RE: Form C-108, Application for Authorization to Inject  
Bilbrey 28A Federal #1; API 30-025-30664  
Lea County, NM  
Section 28, T21S, R32E

**APPLICATION FOR AUTHORIZATION TO INJECT**

**From:** Jones, William V., EMNRD  
**Sent:** Friday, March 16, 2012 3:07 PM  
**To:** 'Slack, Ronnie'  
**Cc:** Ezeanyim, Richard, EMNRD; Kautz, Paul, EMNRD; 'Wesley\_Ingram@blm.gov'  
**Subject:** Disposal application from Devon Energy Production Company, LP: Bilbrey 28A Fed #1 30-075-30664 (Proposed Bell Canyon Disposal) <sup>2</sup>

**PROPOSED FOR SWD**

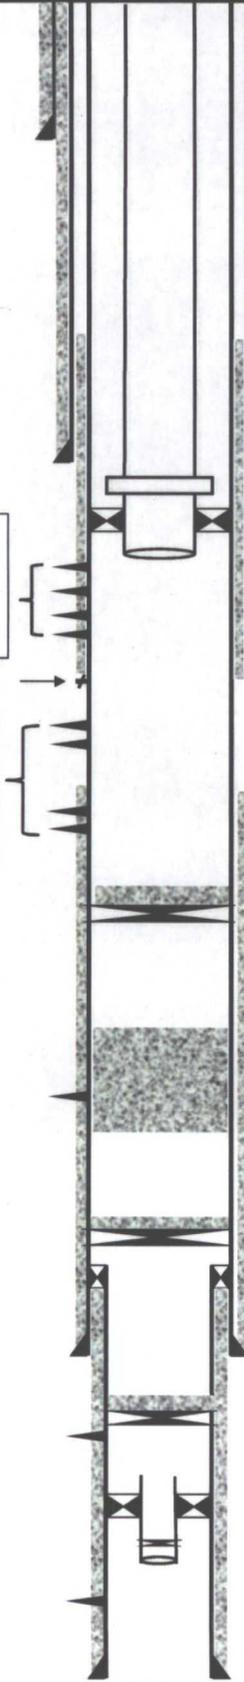
- a. Would you send a notice to the nearest Potash leaseholder? This seems to be in the R-111-P area. *3/19/12*
- b. Does the Bell Canyon in this well always calculate "wet", even at the upper-most Sand? — *LOGS are Bad in Delaware  
NO SHOWS*
- c. Ask your geologist to pick the top and bottom of
  - A. the Salt, *1414 - 4437*
  - B. ~~the Seven Rivers,~~
  - C. ~~the Reef or Queen in this well. (It seems like both Salt and the Reef are present on the logs).~~
- d. The cement bond on this well is very sketchy or poor. Please let me know the results of a bradenhead survey (7" to 9-5/8" annulus) *MIT OK*

- a. Would you send a notice to the nearest Potash leaseholder? This seems to be in the R-111-P area.
- b. Does the Bell Canyon in this well always calculate "wet", even at the upper-most Sand?
- c. Ask your geologist to pick the top and bottom of
  - A. the Salt,
  - B. the Seven Rivers,
  - C. the Reef or Queen in this well. (It seems like both Salt and the Reef are present on the logs).
- d. The cement bond on this well is very sketchy or poor. Please let me know the results of a bradenhead survey (7" to 9-5/8" annulus)

There are no oil or gas shows in the Bell Canyon. In this well, the Bell Canyon calculates wet, even in the uppermost sandstone interval (4720-4740 MD). The uppermost sand would actually calculate higher water saturation because of the lower porosity compared the rest of the Bell Canyon (assuming constant formation water resistivity in all sandstones).

Top Rustler: 624' MD, Top Salt: 1,414' MD, Base Salt: 4,437' MD. The Capitan is not present in this well because the well is basinward (south) of the reef complex. The Seven Rivers and Queen are back-reef Formations that are present north of Capitan reef complex. Neither the Seven Rivers or Queen Formations are present in the Bilbrey 28A Fed 1.

They conducted a braden head survey last week. Pressure up 9-5/8" X 7" annulus to 550 psi for 30 minutes and charted. Held solid.
